PVNGS UNIT 1

**MARKED UP TECHNICAL SPECIFICATIONS
TO SUPPORT NRC GENERIC LETTER 88-16**

FIGURE 3.1-1A
SHUTDOWN MARGIN vs. COLD LEG TEMPERATURE

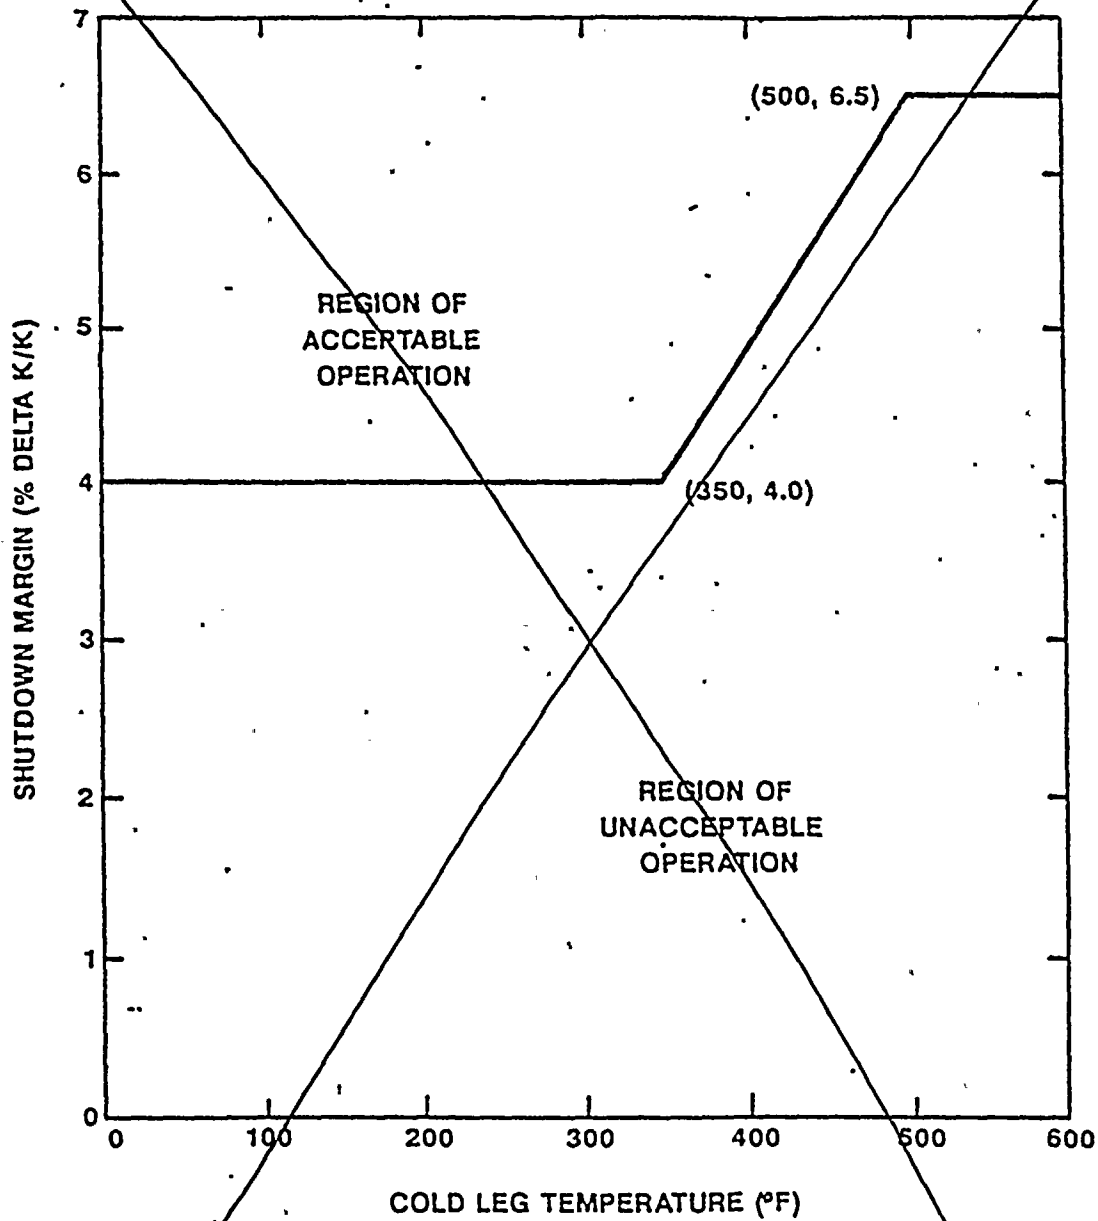
- a. The SHUTDOWN MARGIN shall be greater than or equal to that shown in Figure 3.1-1A, and
- b. For T_{cold} less than or equal to 500°F, K_{N-1} shall be less than 0.99.

- a. With the SHUTDOWN MARGIN less than that in Figure 3.1-1A, immediately initiate and continue boration at greater than or equal to 26 gpm to the reactor coolant system of a solution containing greater than or equal to 4000 ppm boron or equivalent until the required SHUTDOWN MARGIN is restored, and
- b. With T_{cold} less than or equal to 500°F and K_{N-1} greater than or equal to 0.99, immediately vary CEA positions and/or initiate and continue boration at greater than or equal to 26 gpm to the reactor coolant system of a solution containing greater than or equal to 4000 ppm boron or equivalent until the required K_{N-1} is restored.

~~DELETE PAGE~~

FIG. 1-1
 ALLOWABLE MTC MODES 1 AND 2
 PALO VERDE UNIT 1 CYCLE 2

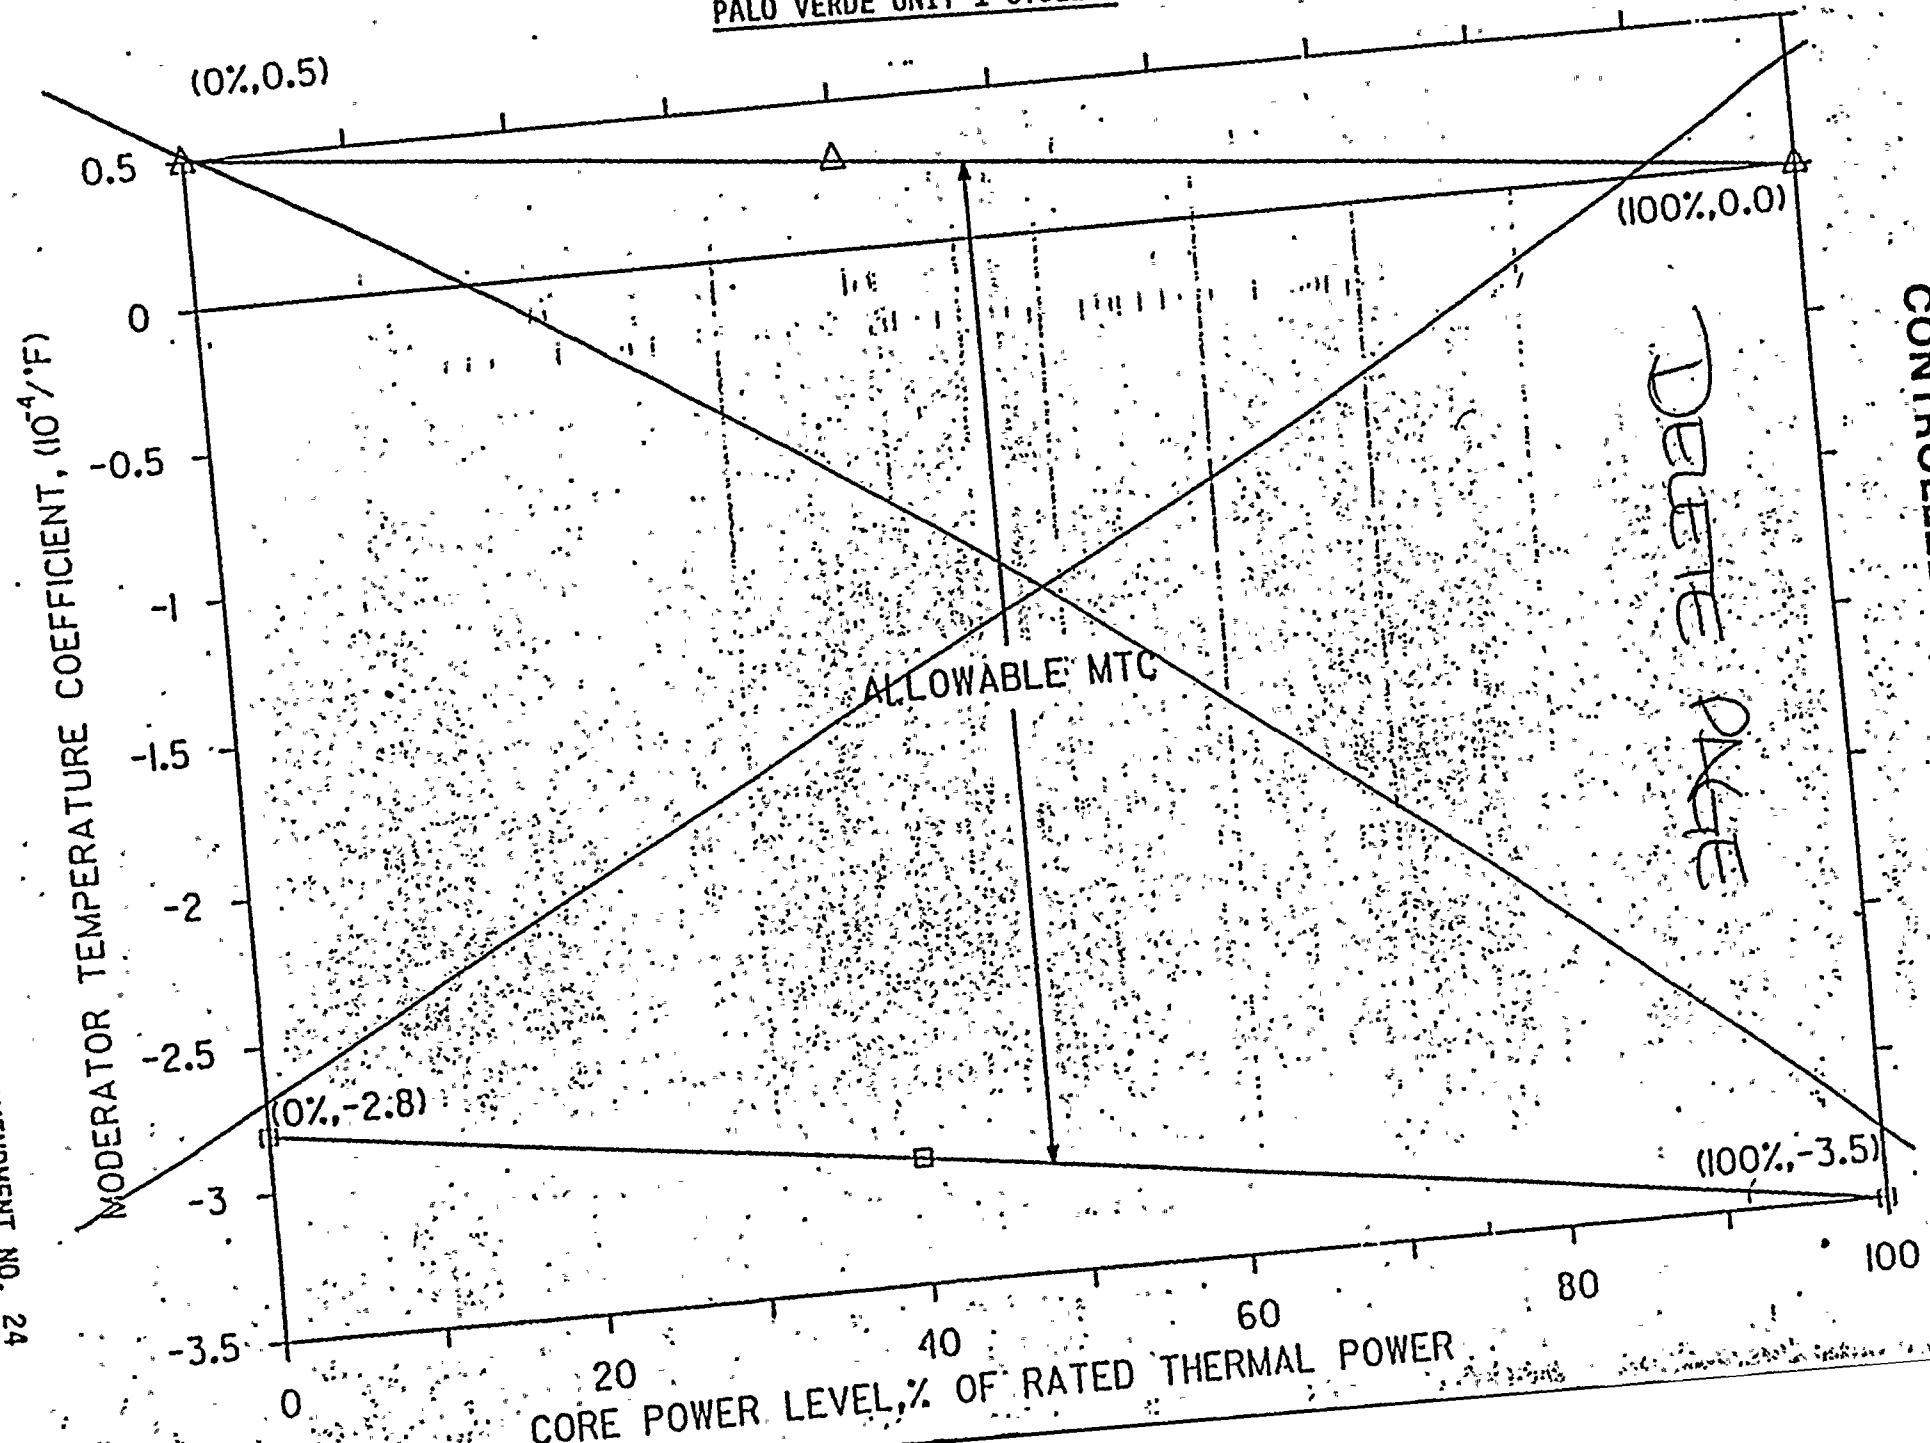
specified in the CORE OPERATING LIMITS REPORT
 3.1.1.3 The moderator temperature coefficient (MTC) shall be within the area of Acceptable Operation ~~shown on Figure 3.1-1.~~

ACTION: specified in the CORE OPERATING LIMITS REPORT
 With the moderator temperature coefficient outside the area of Acceptable Operation ~~shown on Figure 3.1-1,~~ be in at least HOT STANDBY within 6 hours.

DELETE PAGE

FIGURE 3.1-3

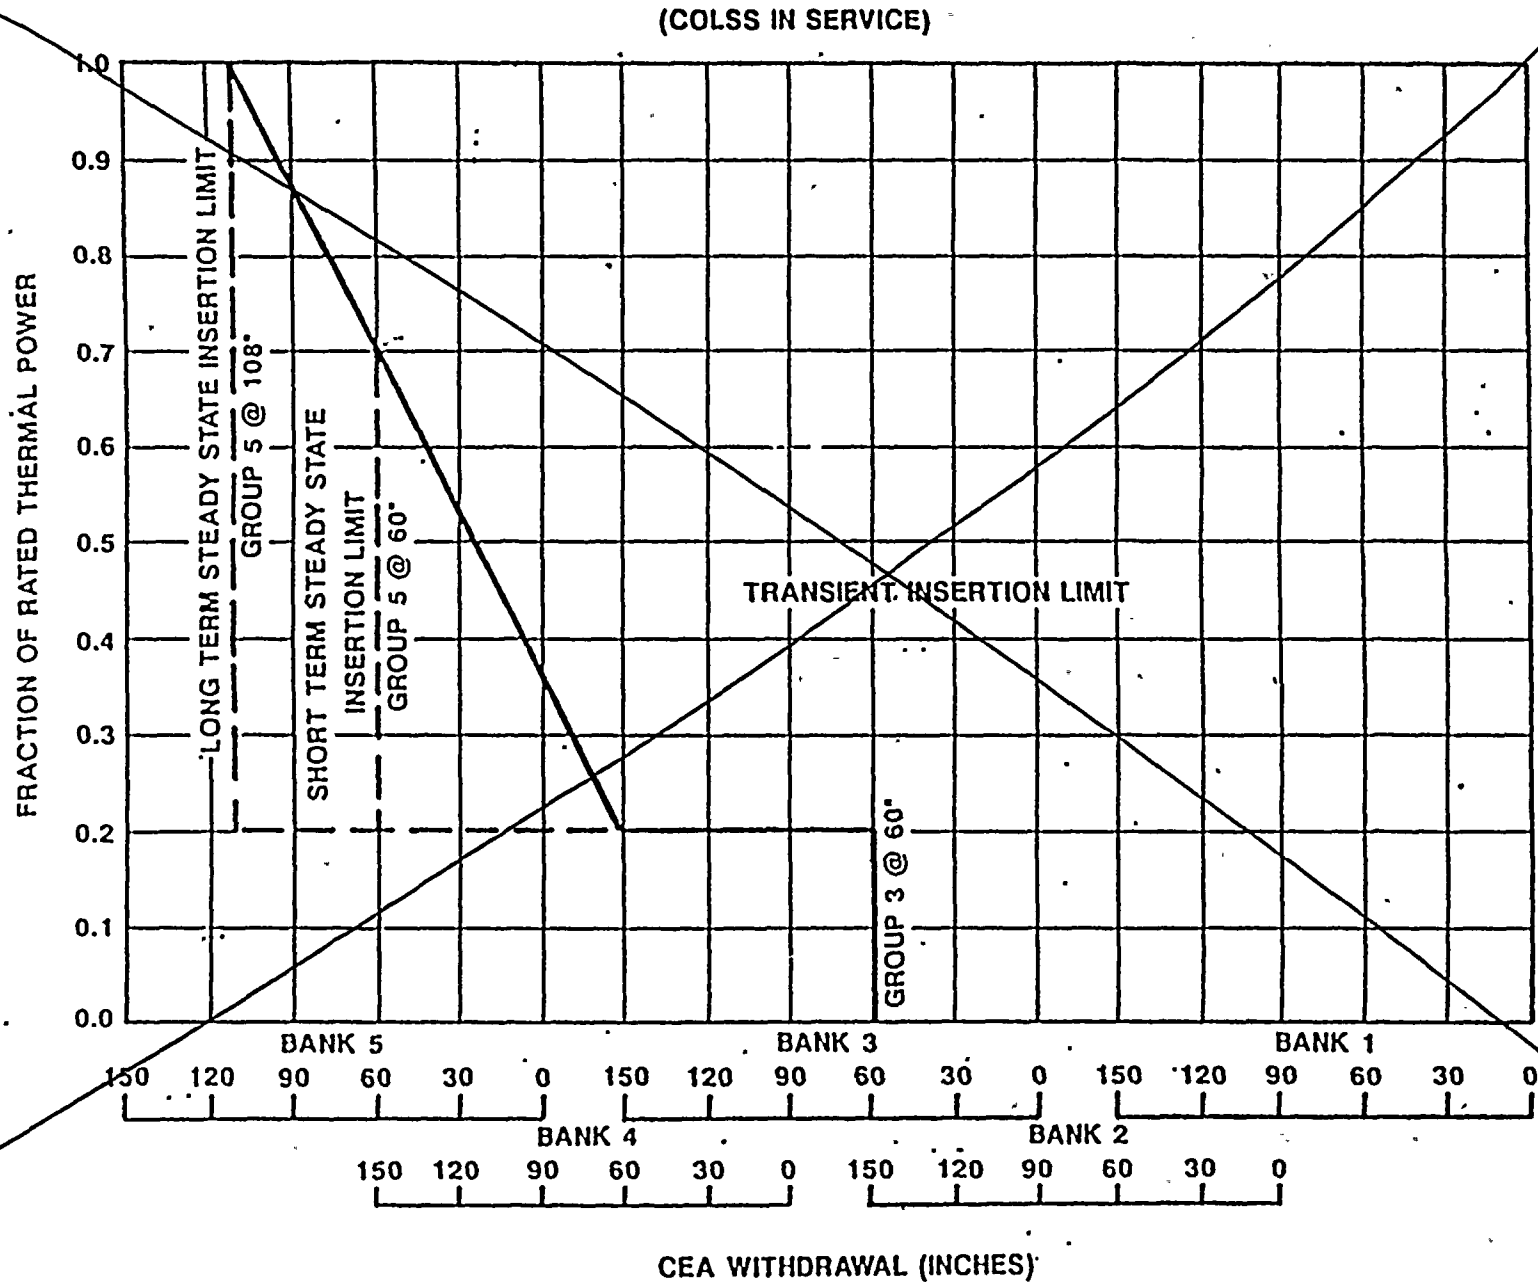
1. The regulating CEA groups shall be limited to the withdrawal sequence, and to the insertion limits~~##~~ shown on Figure 3.1-3 when the COLSS is in service or shown on Figure 3.1-4 when the COLSS is not in service. The CEA insertion between the Long Term Steady State Insertion Limits and the Transient Insertion Limits is restricted to:

DELETE PAGE

FIGURE 3.1-4
CEA INSERTION LIMITS vs. THERMAL POWER
(COLSS OUT OF SERVICE)

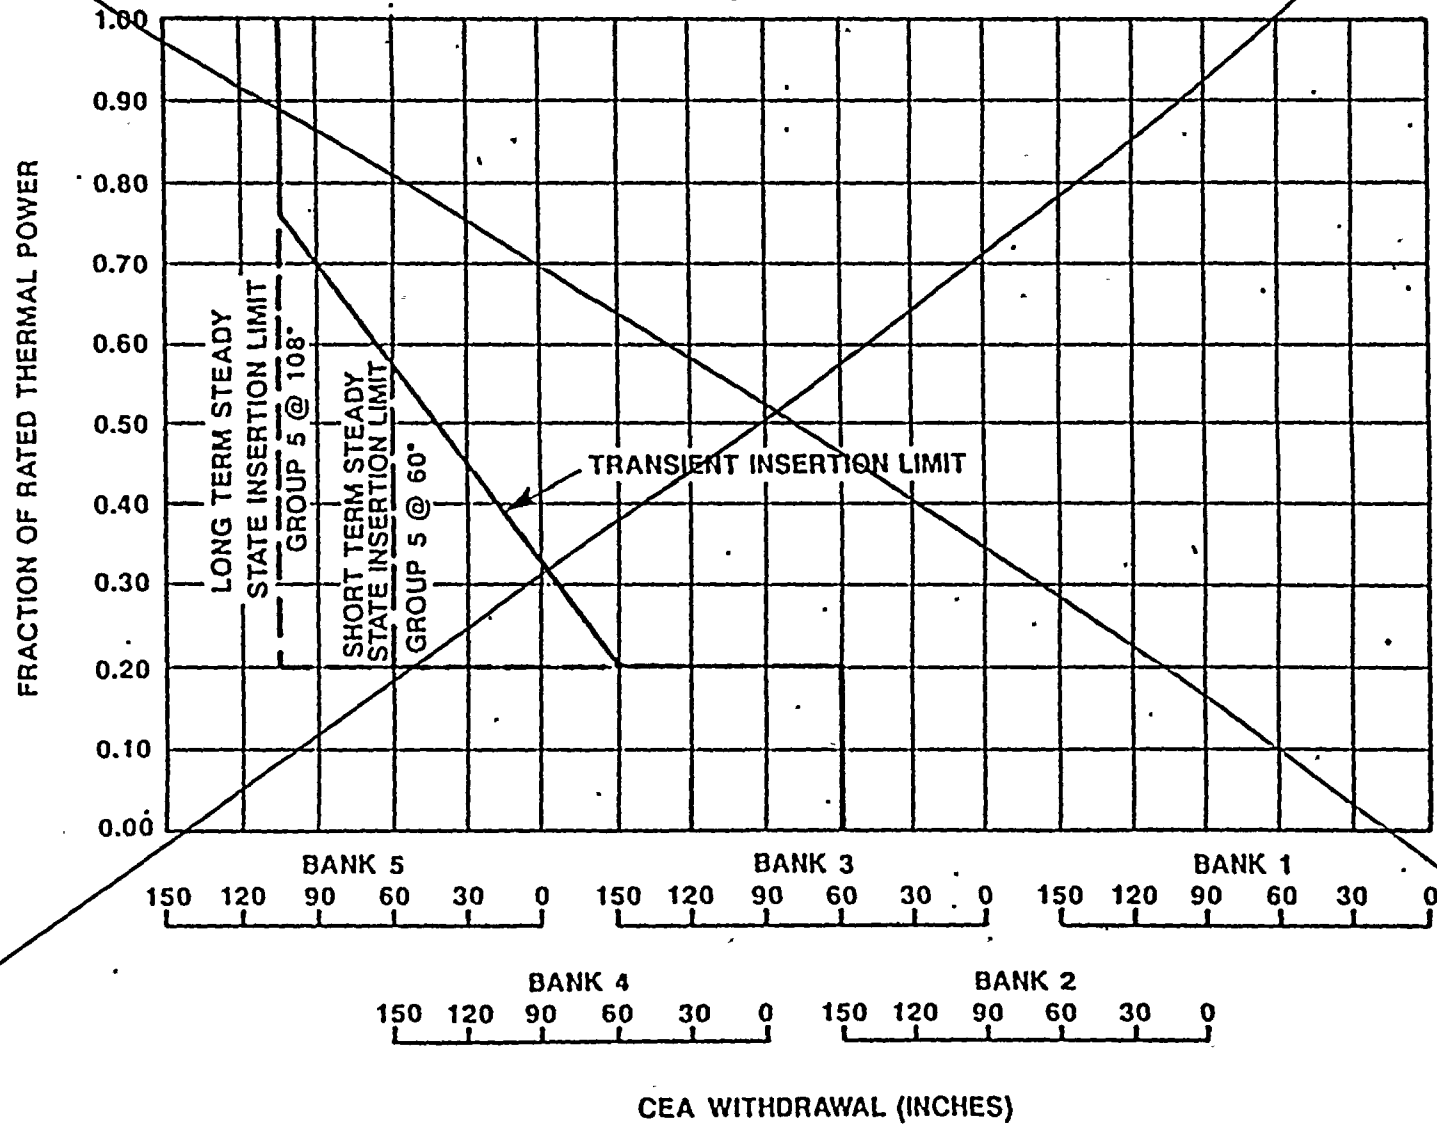
DELETE PAGE

FIGURE 3.1-5

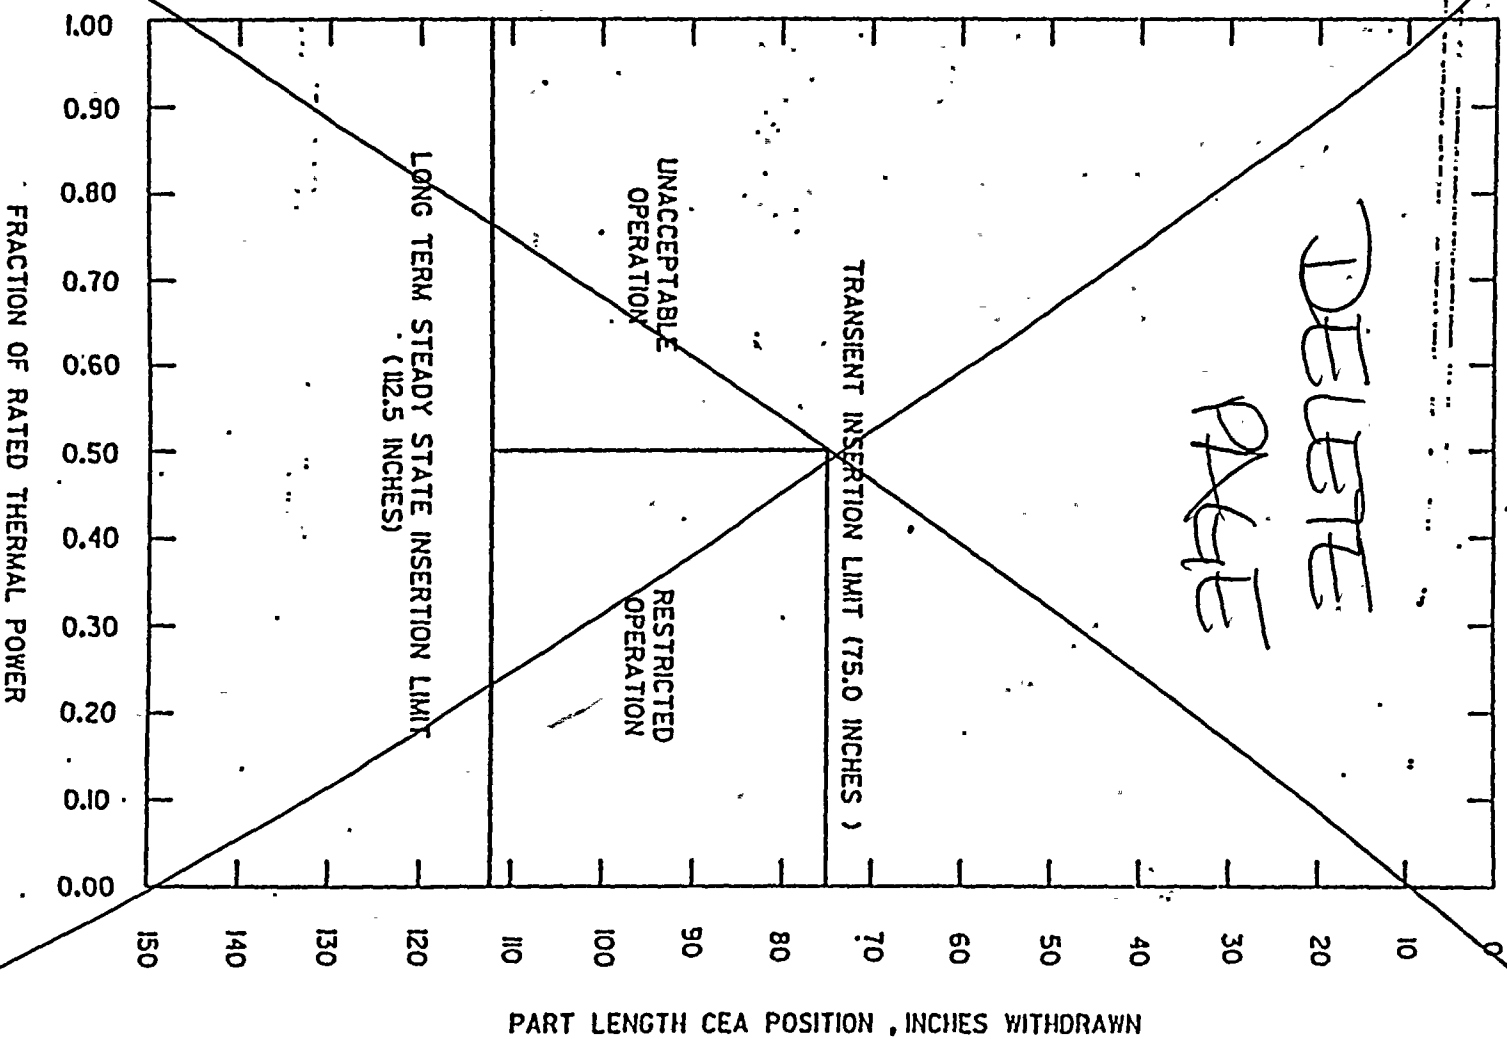
- a. ~~One or more CEACs OPERABLE~~
specified in the CORE OPERATING LIMITS REPORT
 The part length CEA groups shall be limited to the insertion limits shown on Figure 3.1-5 with PLCEA insertion between the Long Term Steady State Insertion Limit and the Transient Insertion Limit restricted to:

~~DELETE~~
~~PLATE~~
